Town of Hilton Head Island
Design Review Board
Special Meeting
Wednesday, January 12, 2022 – 1:30 p.m.
AGENDA

i. Lucky Beach Bar + Kitchen, DRB-002869-2021

DESIGN TEAM/DRB COMMENT SHEET

PROJECT NAME: Lucky Beach Bar + Kitchen

1 PROPOSED SITE PLAN
 A100 SCALE: 3/32" = 1'-0"

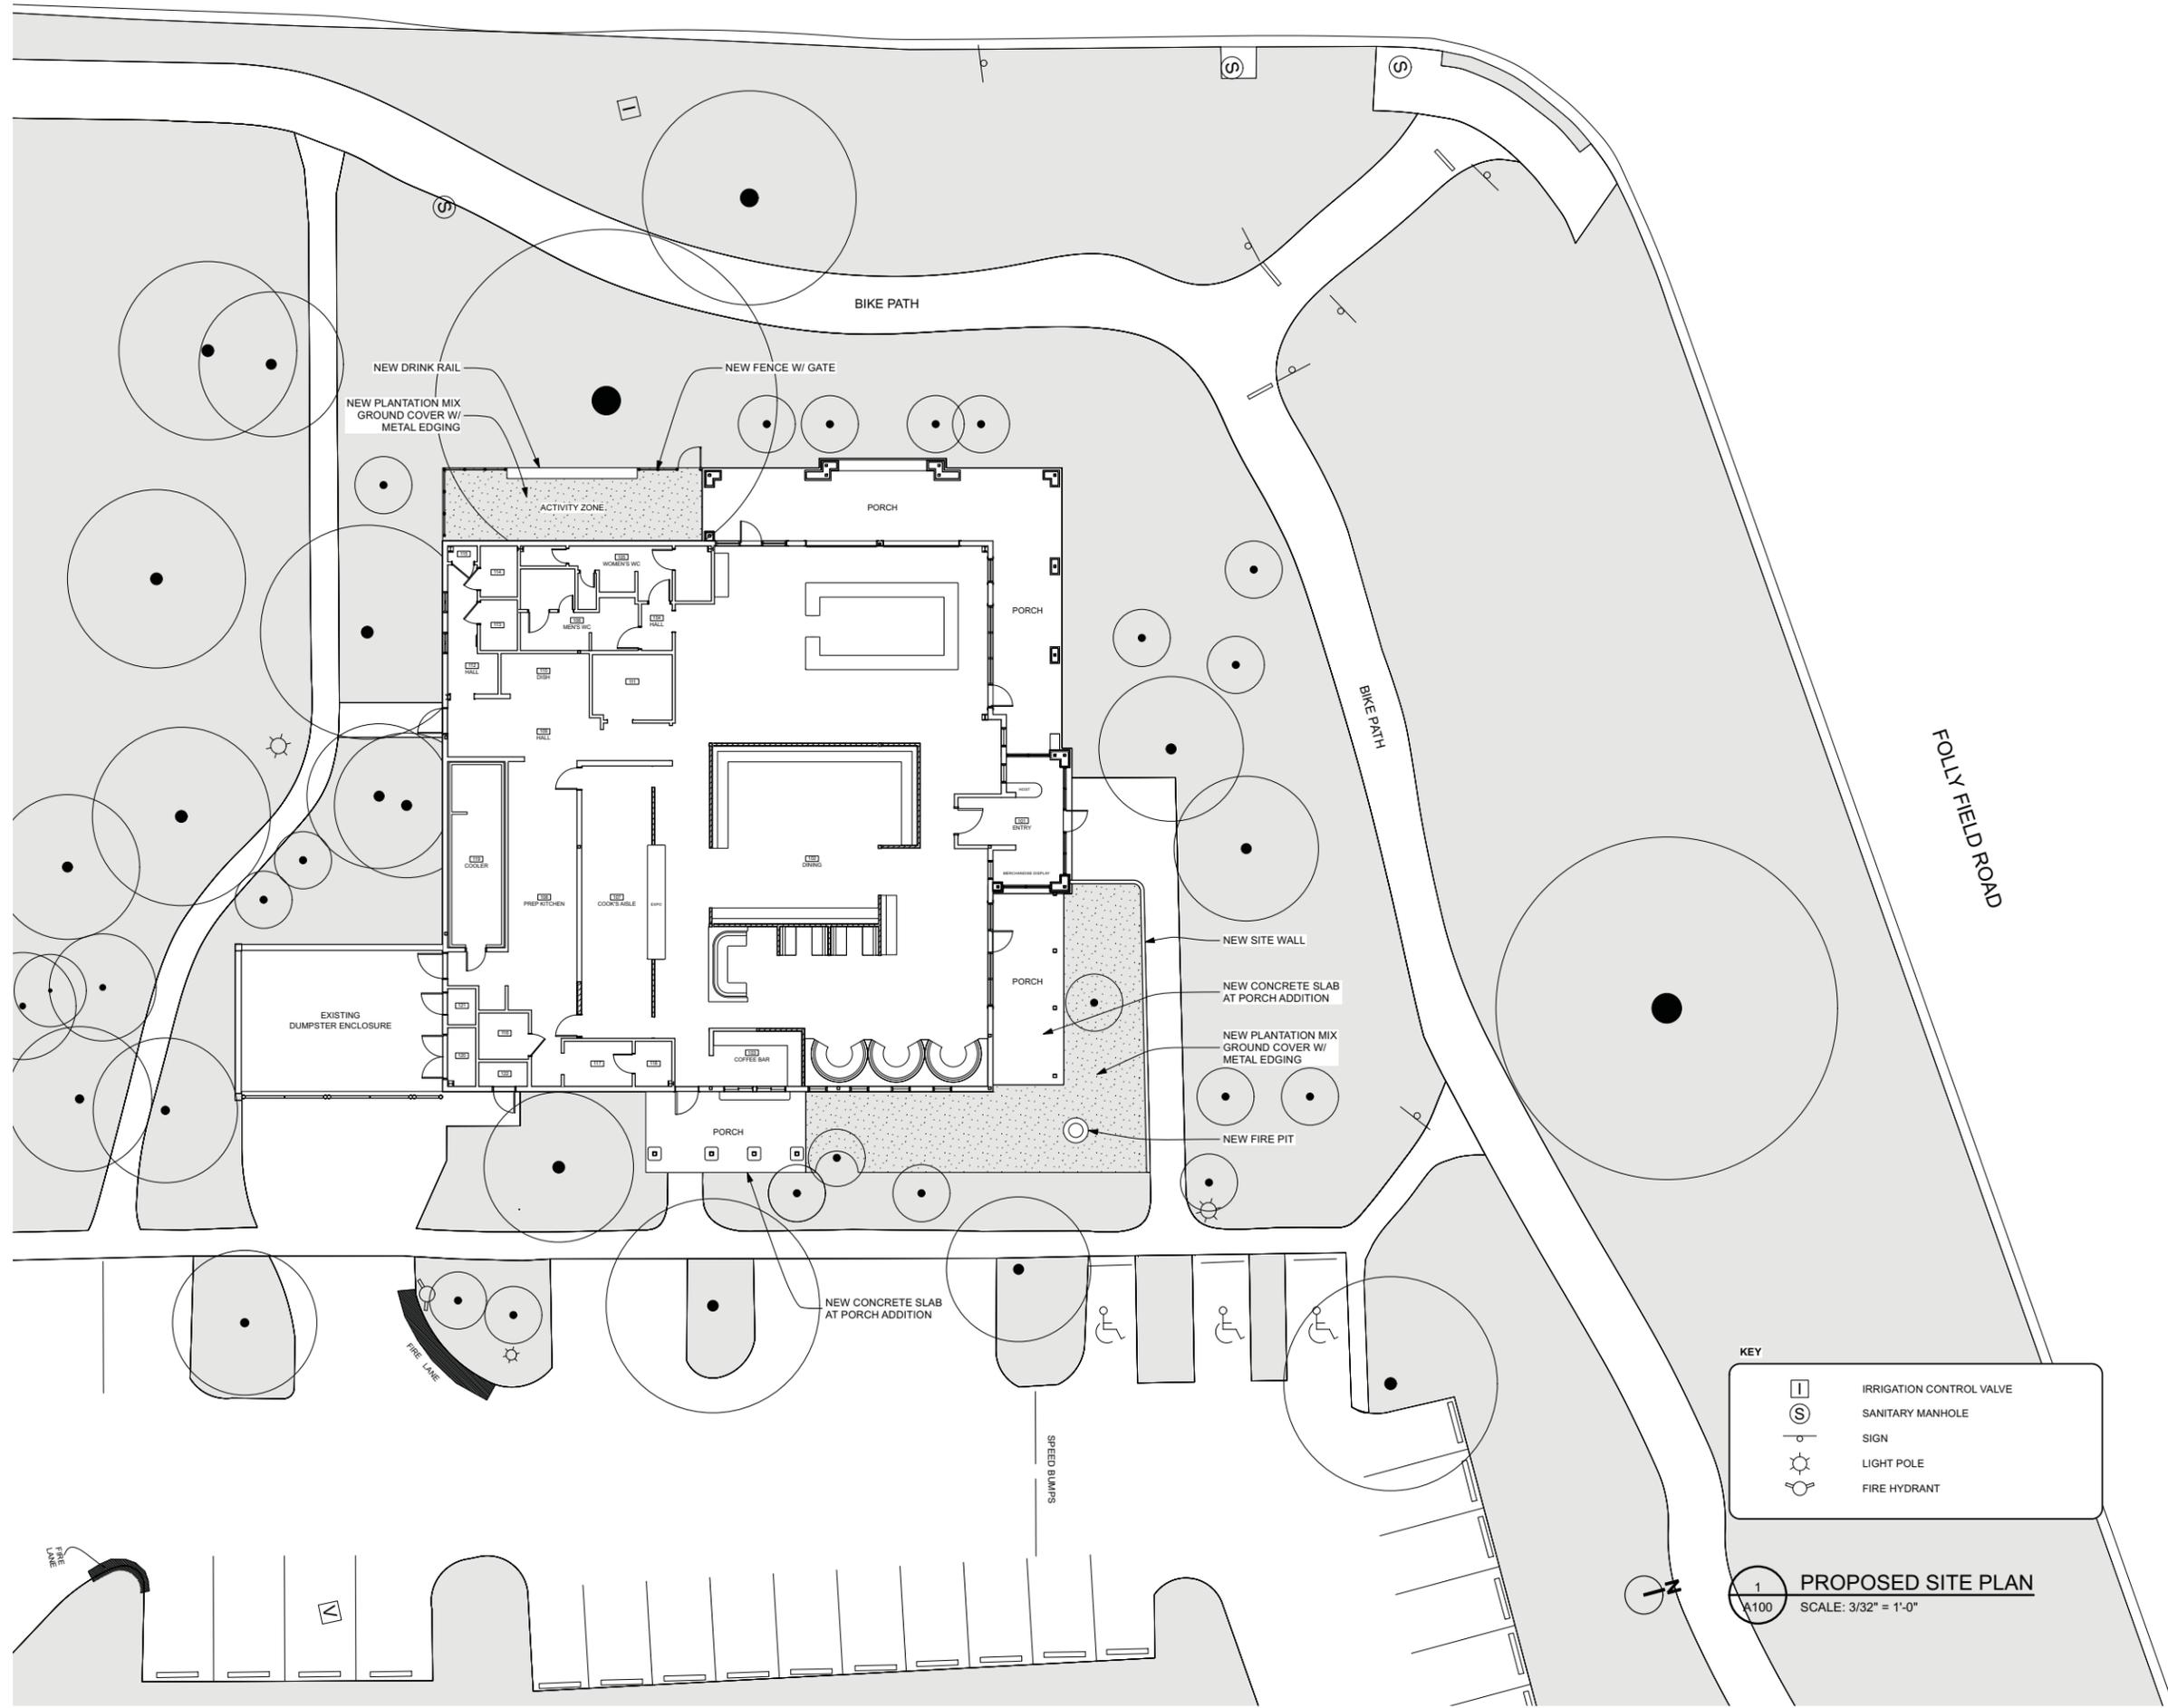
1. Provide a color board.
2. Provide construction details of the knee wall and railing.
3. Provide a landscape plan.
4. Revise the site plan to show:
 - a. Tree protection
 - b. Street buffer
 - c. Outdoor eating area ground surface.

NATURAL RESOURCE PROTECTION				
DESIGN GUIDE/LMO CRITERIA	Complies Yes	No	Not Applicable	Comments or Conditions
An effort has been made to preserve existing trees and under story plants	<input type="checkbox"/>	<input checked="" type="checkbox"/>	<input type="checkbox"/>	Specify on a plan the location of tree protection fence around the live oak adjacent to the porch extension on the William Hilton Parkway side of the building

1 PROPOSED FURNITURE PLAN
 A102 SCALE 3/16" = 1'-0"

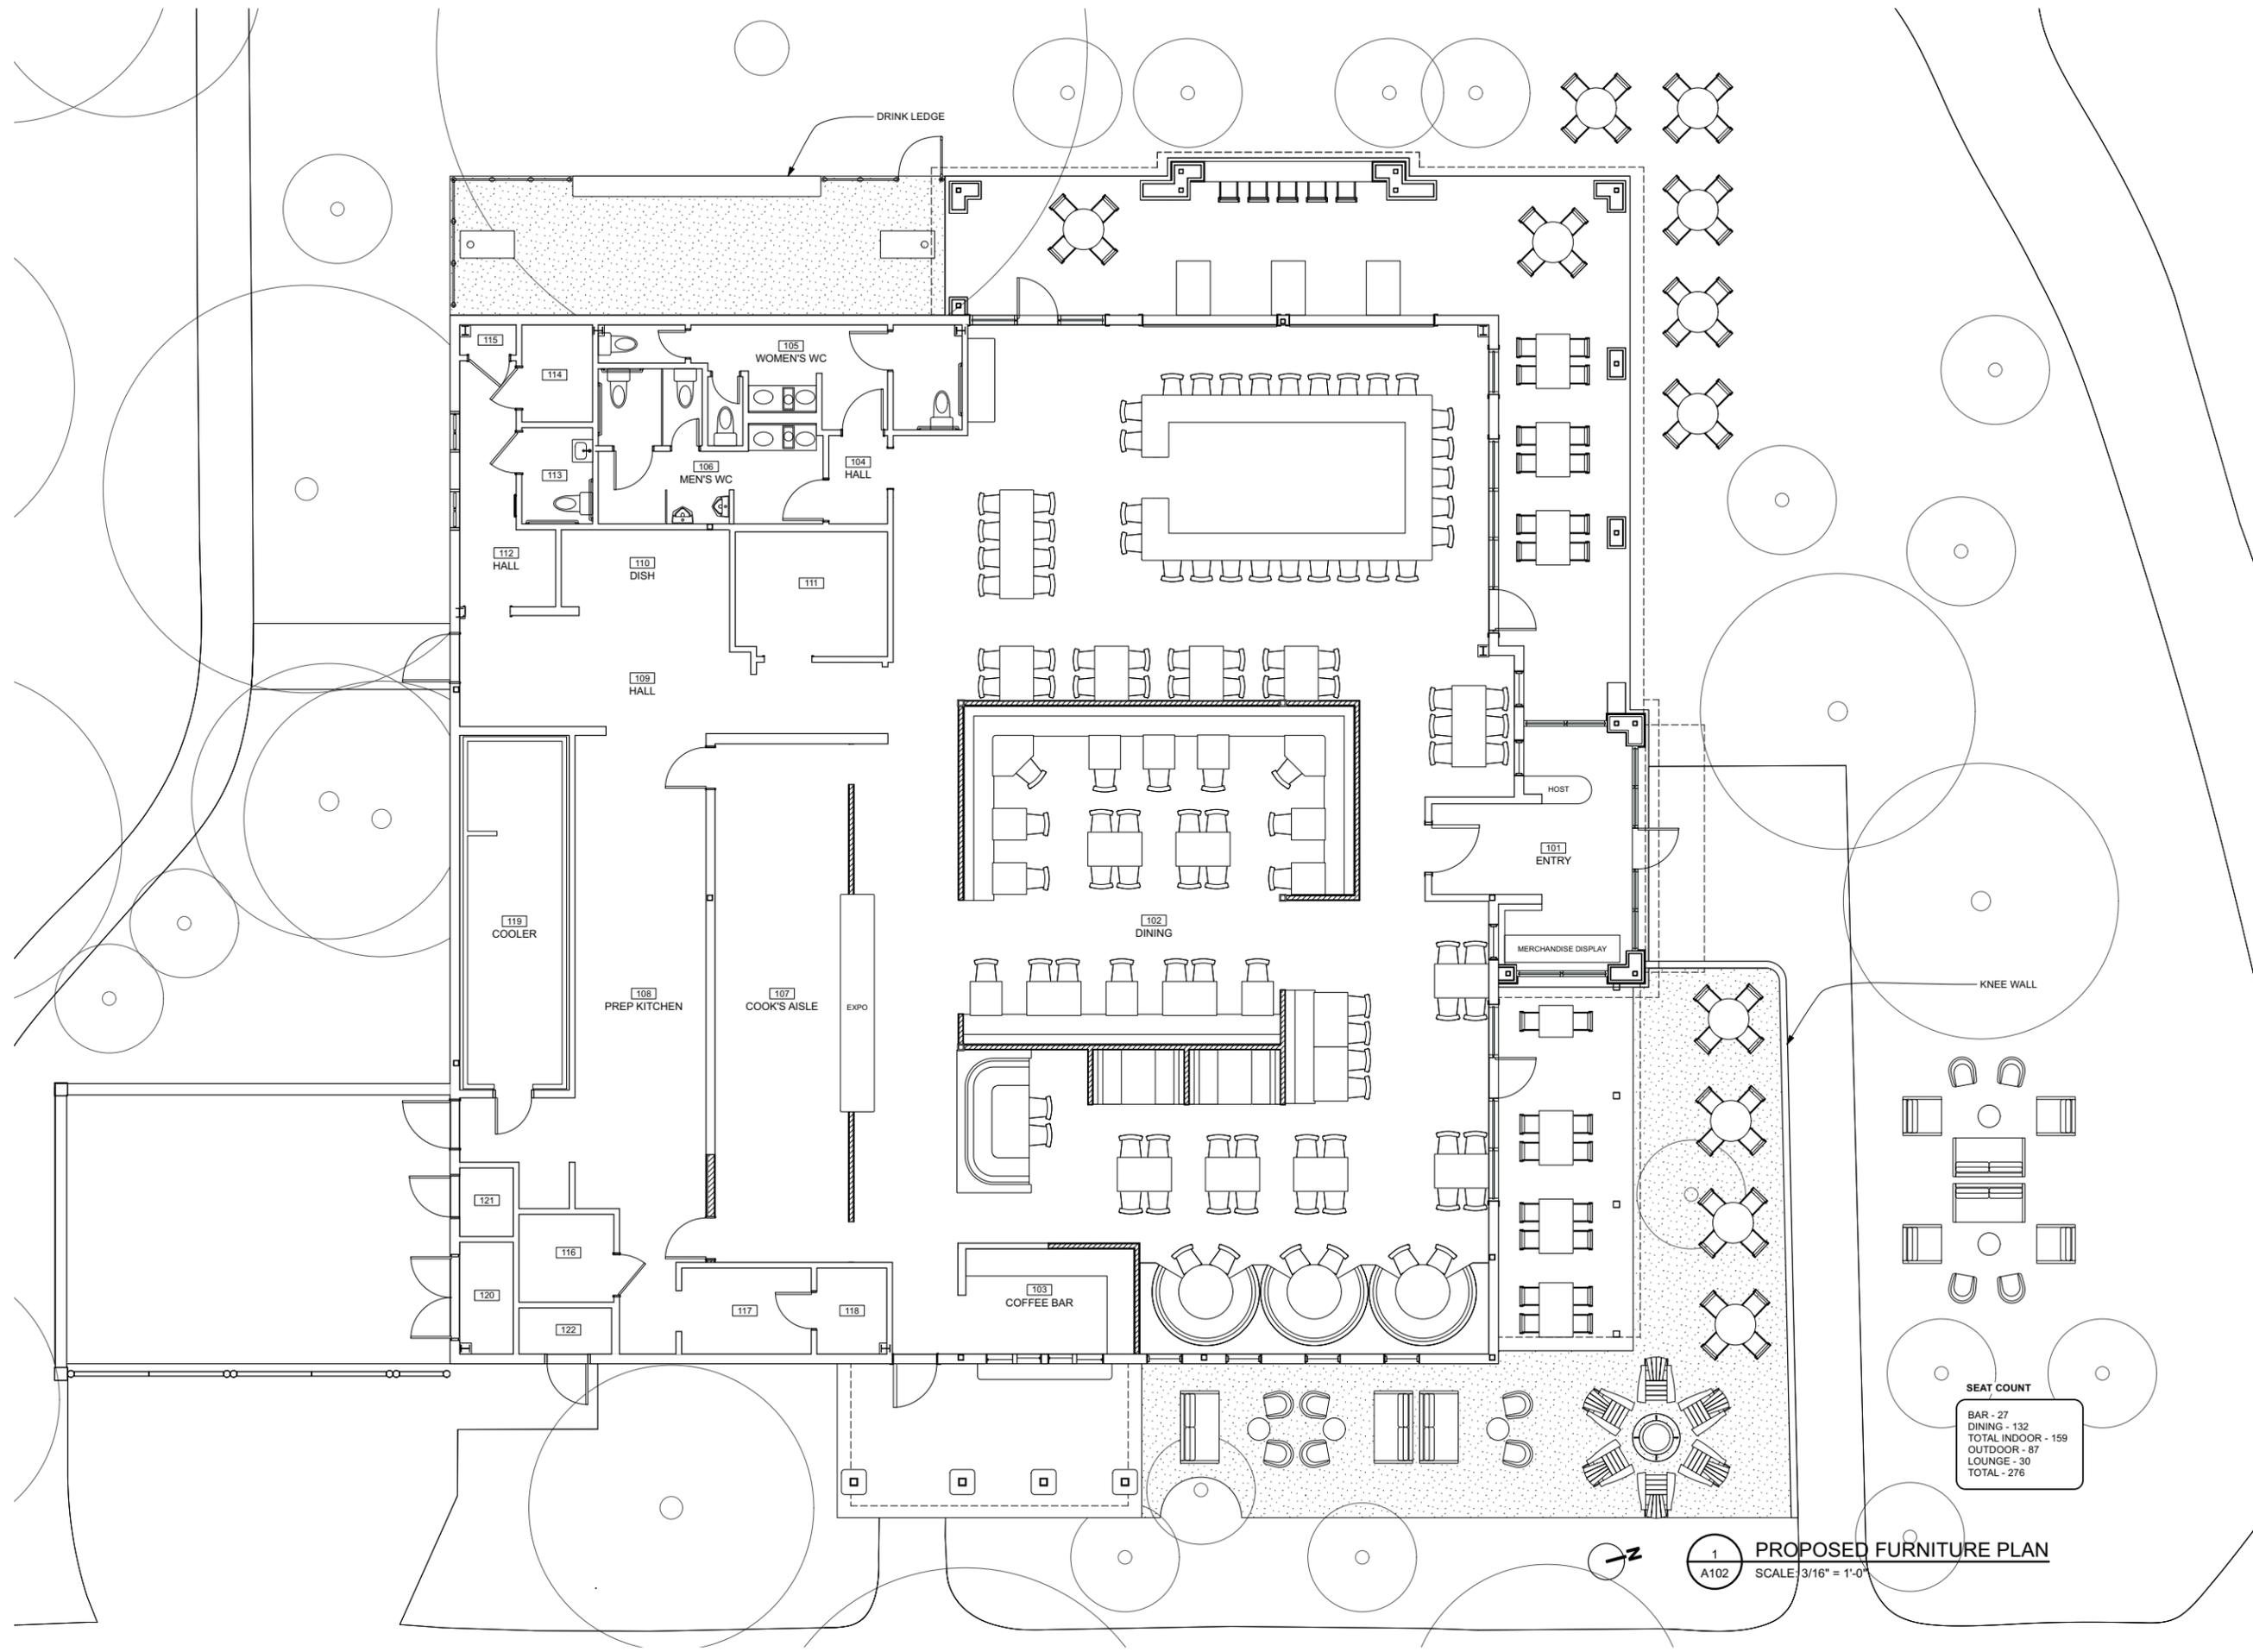
MISC COMMENTS/QUESTIONS				
1. Add the Street buffer to the Site Plan. Restaurant dining is not a permitted use within the buffer. Seating shown on sheet A102.				
2. Specify the ground plane treatment under any proposed outdoor seating on Sheet A102. Staff's concern as a matter of good site design is to avoid unsightly failure on the ground plane / surface and or areas of exposed dirt.
